ITEM: 6.4	REPORT SUMMARY MINOR VARIANCE APPLICATION FILE NUMBER A050/25
-----------	---

CITY WARD #:	1
APPLICANT:	Perasanya Bakeerathan & Godfrey Bakeerathan
AGENT:	Alicia Dusil (Dusil Design And Landscape Inc.)
PROPERTY:	83 Lacrosse Trail, Kleinburg
ZONING DESIGNATION:	See below.
VAUGHAN OFFICIAL PLAN (2010) DESIGNATION:	Vaughan Official Plan 2010 ('VOP 2010'): "KN Low-Rise Residential II" by Schedule B3 - North Kleinburg-Nashville Secondary Plan (Chapter 11.8, Volume 2)
RELATED DEVELOPMENT APPLICATIONS:	None
PURPOSE OF APPLICATION:	Relief from the Zoning By-law is being requested to permit a proposed inground pool, an existing deck in the rear yard, a residential accessory structure and reduced landscaping requirements.

A050_25 Minor Variance Application

Landscape Plan: BAKEERATHAN PROPERTY
83 LACROSSE TRAIL
VAUGHN ONTARIO
L4H 4S8

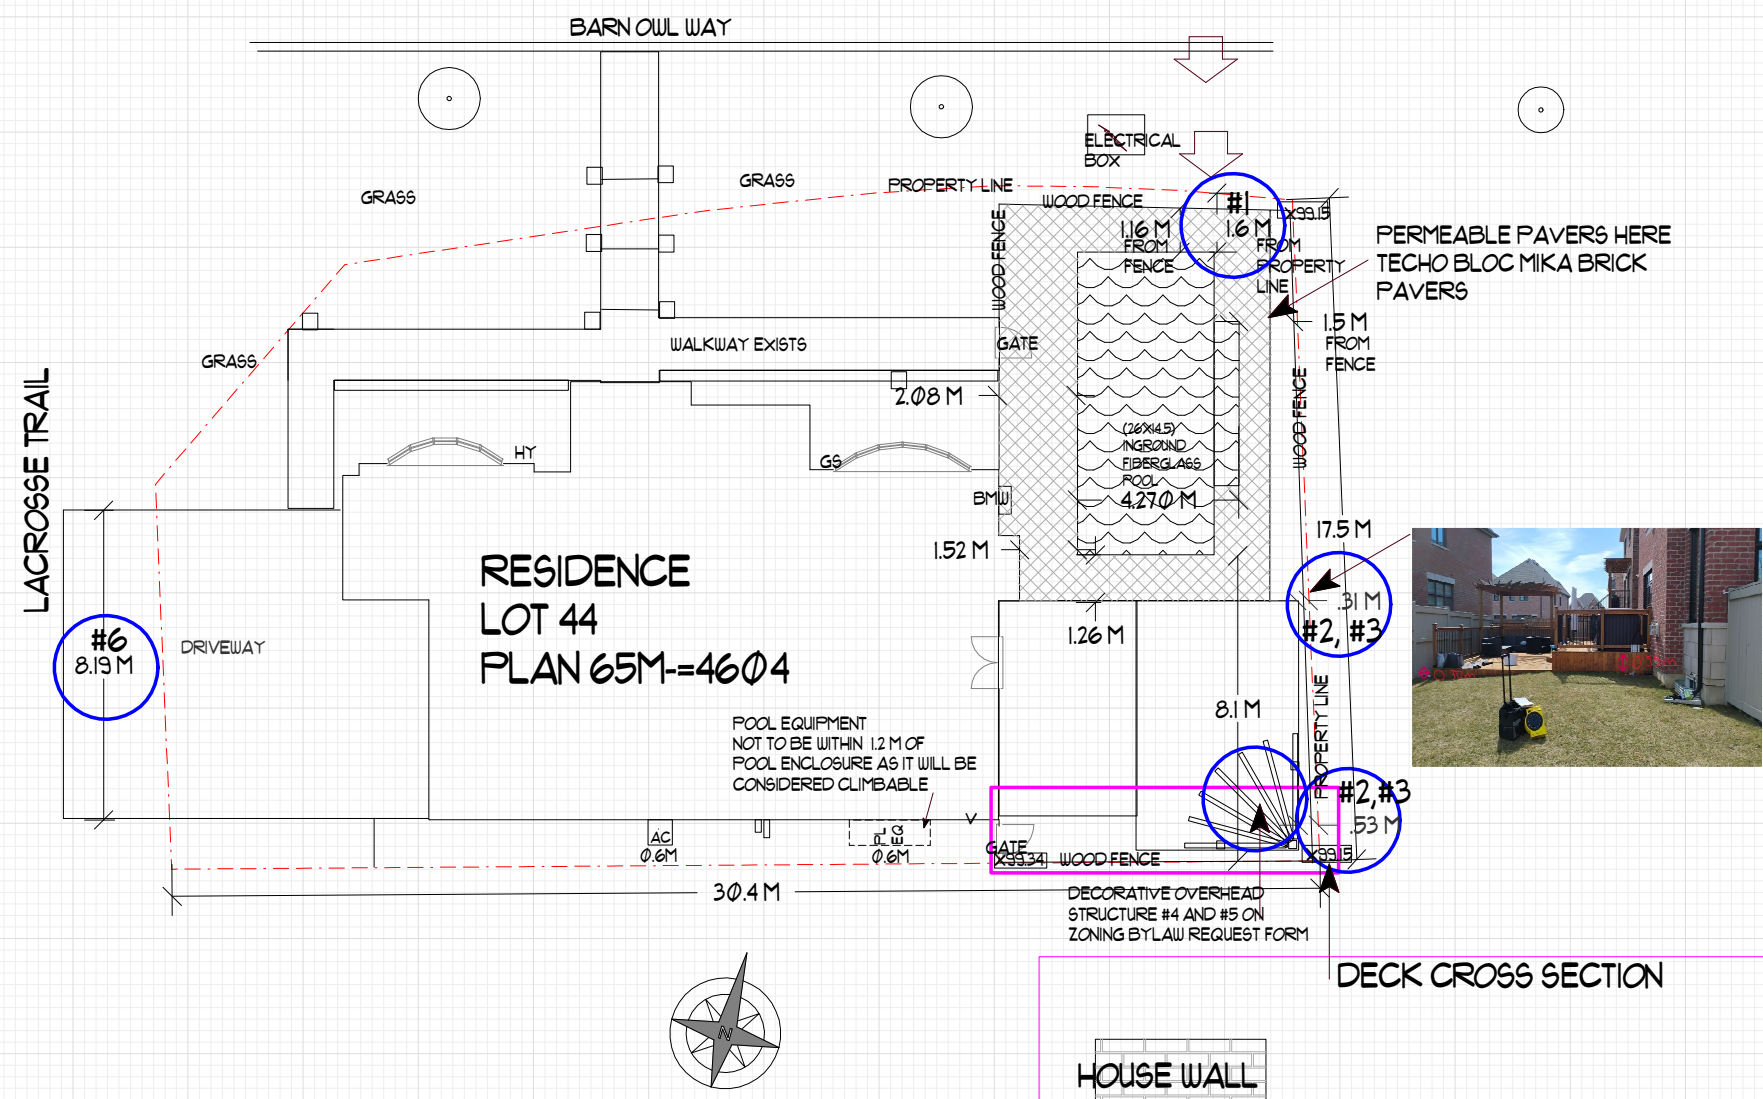
The Owner is seeking relief to permit a deck, a pergola, and a swimming pool in the rear yard with the above noted variances.

The Development and Parks Planning Department has no objections to Variance 1 to reduce the exterior side lot line setback of the proposed swimming pool from 3 m to 1.6 m. The property is a corner lot, and a wooden fence exists along the exterior side lot line to provide buffer from the public realm and mitigate privacy concerns. The proposed 1.6 m setback provides sufficient space for access and maintenance.

The Development and Parks Planning Department has no objections to Variances 2 and 3 to permit the proposed encroachment of the deck into the rear yard. The two-tiered deck is tallest towards the dwelling and steps down to 0.2 m in height towards the rear lot line. Due to the minimal height of the deck, the proposed 0.3 m setback from the rear lot line does not impede access and maintenance, and does not incur massing impacts on the neighbouring properties.

The Development and Parks Planning Department has no objections to Variances 4 and 5 to reduce the minimum rear and side setbacks of the proposed pergola to 0.3 m. The proposed pergola is unenclosed, has a height of 2.6 m measured from grade, and is structural supported by three columns. The 0.3 m setback does not impede access and

The Development and Parks Planning Department has no objections to Variance 6 to permit the proposed landscaping reduction in the front yard. The property, being a corner lot, is well vegetated in the exterior side yard. Additional soft landscaping exists within the City-owned portion of the boulevard. Development Engineering staff have reviewed the landscaping reduction and do not anticipate any stormwater runoff concerns.

1. That the Owner provide photo evidence of the removal of guardrails around the perimeter of the deck to the satisfaction of the Development and Parks Planning Department.
